**From:** Nilesh Thool  
**Sent:** Friday, 17 March 2017 3:49 PM  
**To:** David Kroning; Neal Krautz  
**Cc:** John Kakourakis; Darryl Airlie  
**Subject:** FW: Northshore Hamilton - Remora MacArthur Upgrade drawings

The latest set of drawings documents submitted by EDQ for **Northshore Hamilton - Remora MacArthur Upgrade project** have been placed in RM for your access and reference under the following -

**Subject:** Northshore Hamilton - Remora MacArthur Upgrade drawings

ISSUE: CE006642-001-TF-301 / 1 of 2

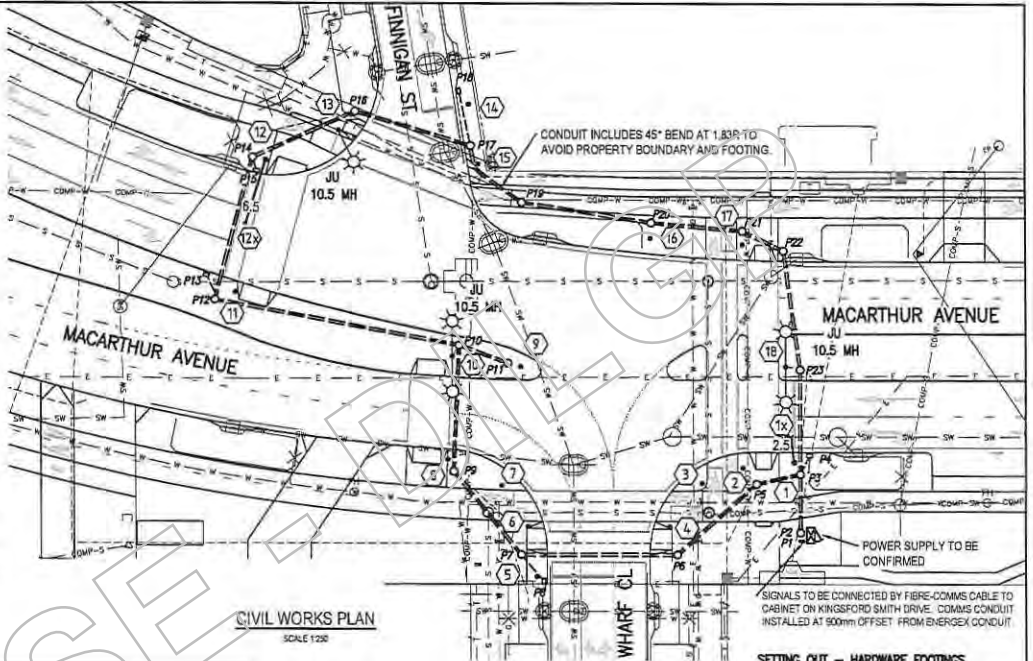
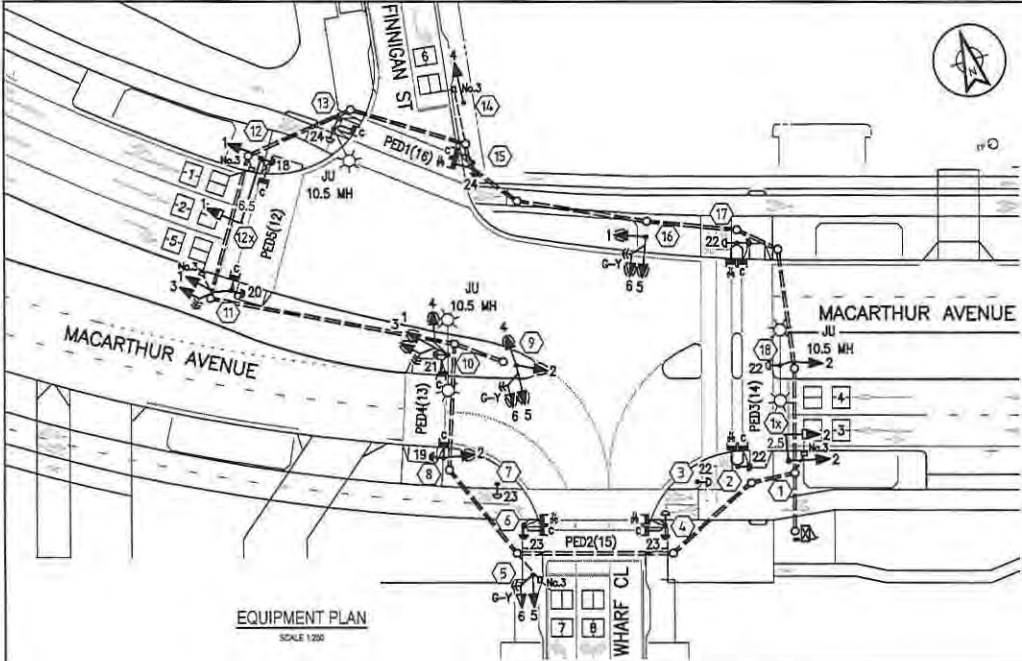
If EDQ have an approved set of drawings, can they please provide these.

Part of the approval process for CRU is that all drawing submitted for approval would need to be supplied on Councils drawing frame (which is available on BCC's website).

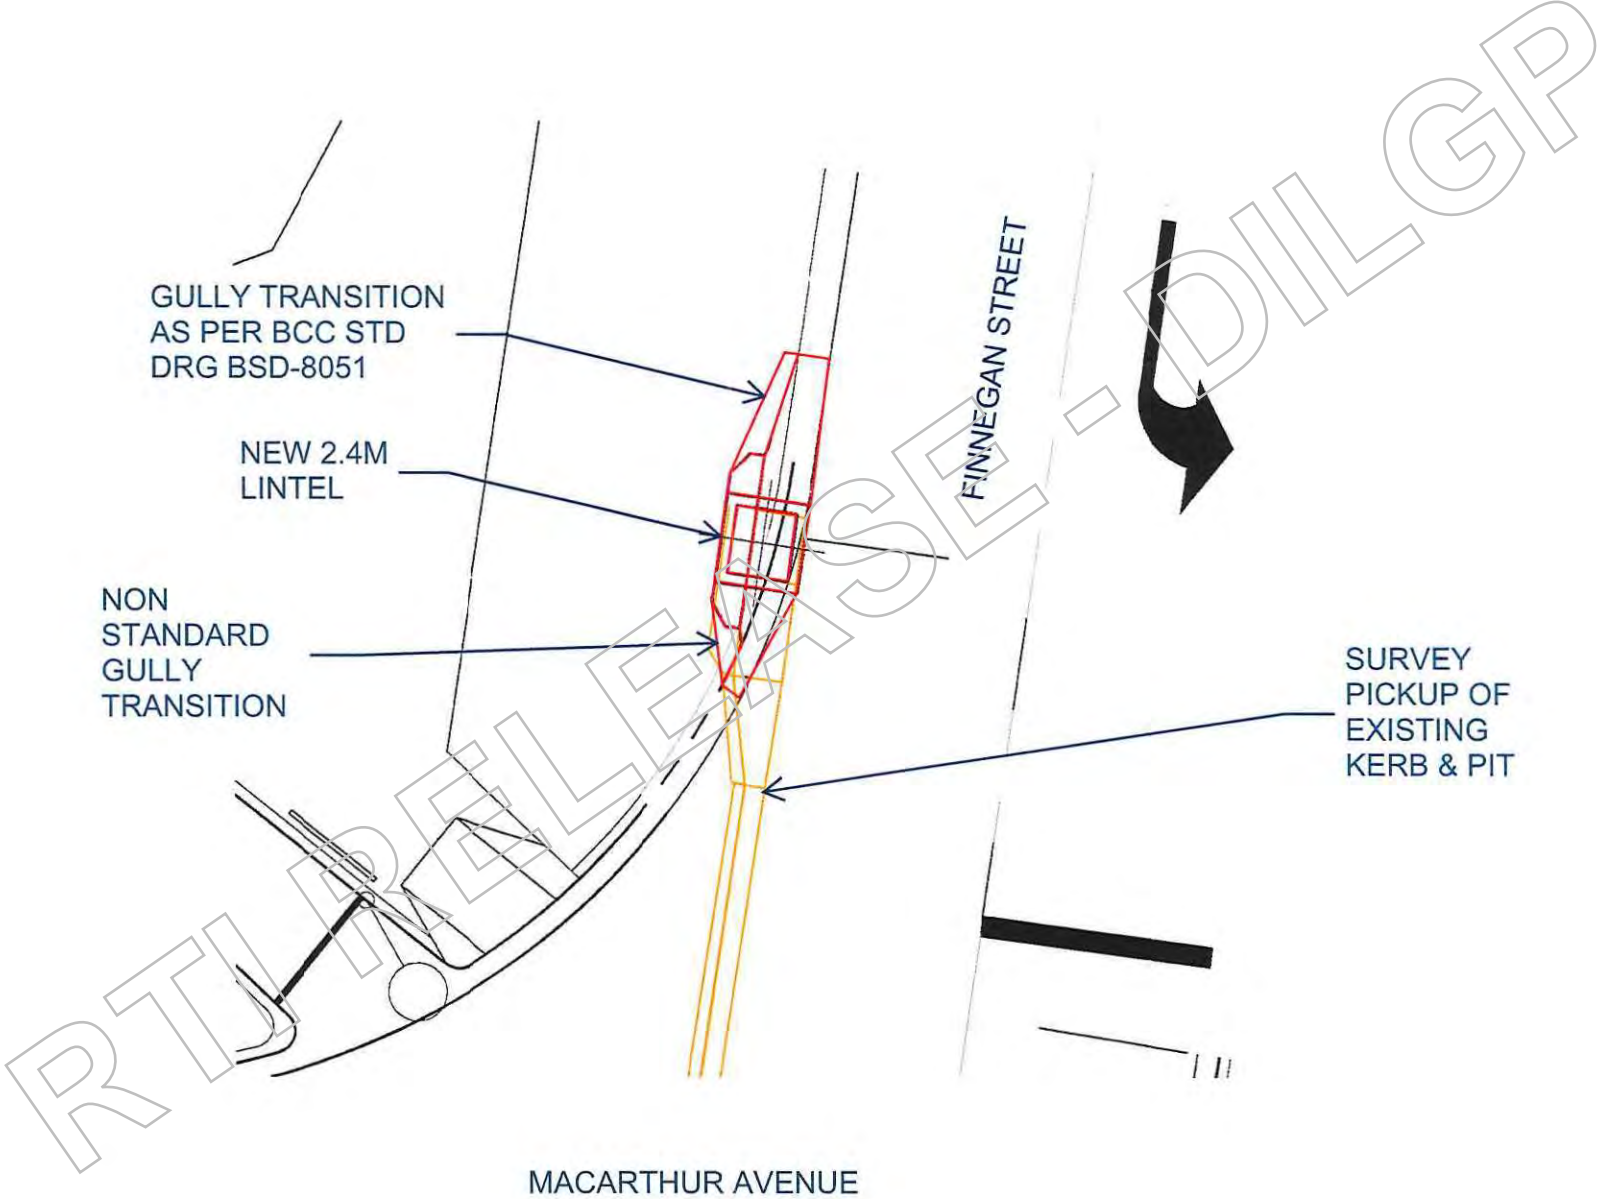
Please see email below from our design consultant. Can you provide advice regards to absolute minimums to make things work?

With regards to the interim stop fronting the park on drawing FL002, we attach this for discussion purposes. We have some concerns with this layout as the in lane stop does not allow enough passing room between the edge of the linemarking and the kerb line to the centre median. I am a bit concerned this is a potential conflict area as a motorist would try to pass the bus, with limited space available. It may be better to consider removing some carparks or partially indenting this area to allow passing room.

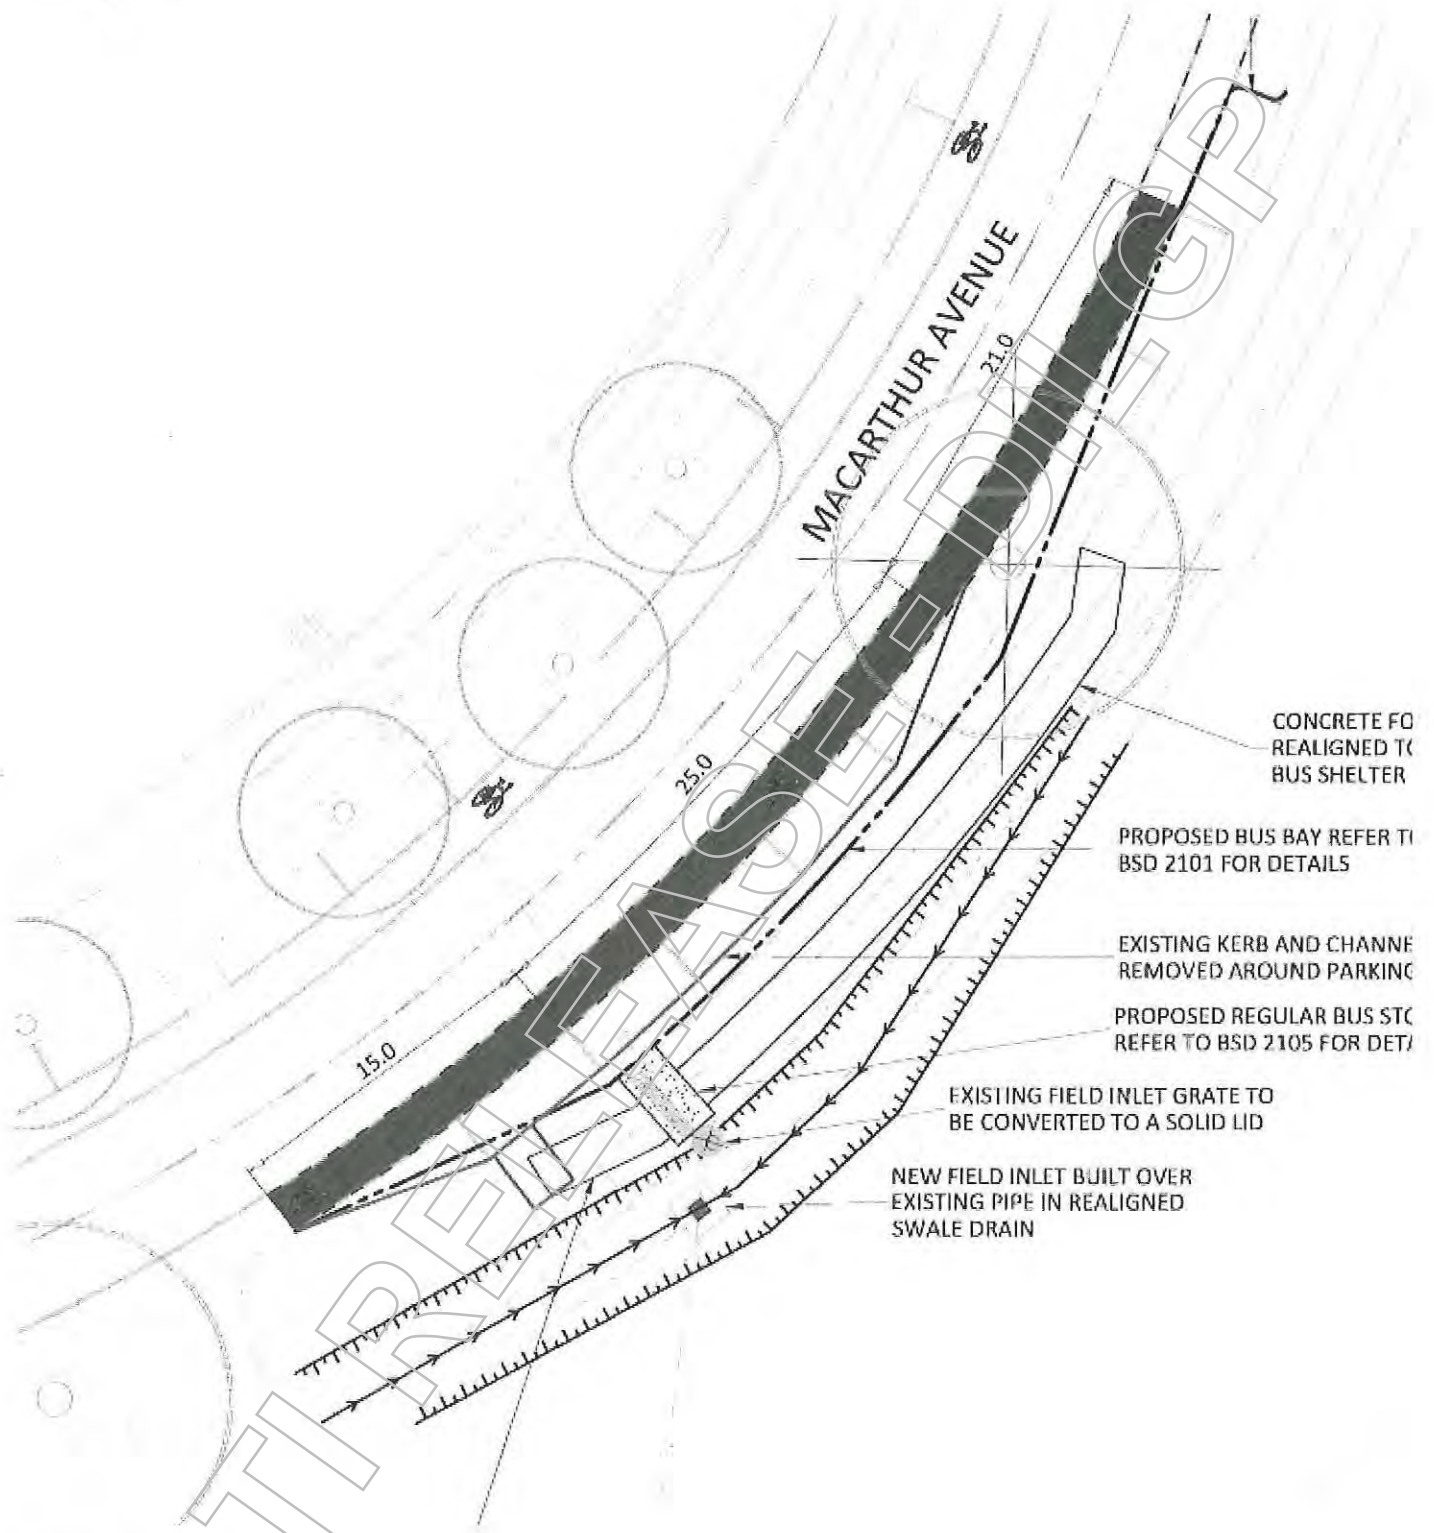
I'd like to amend the interim stop at the café to reduce the work required. Below in pink shows my thoughts which BT and BCC didn't seem to have a problem with. I understand the width is not as per standard drawing and the taper lengths are also shorter than standard but We need to look at ways that don't require significant upgrades and impact on the figs.
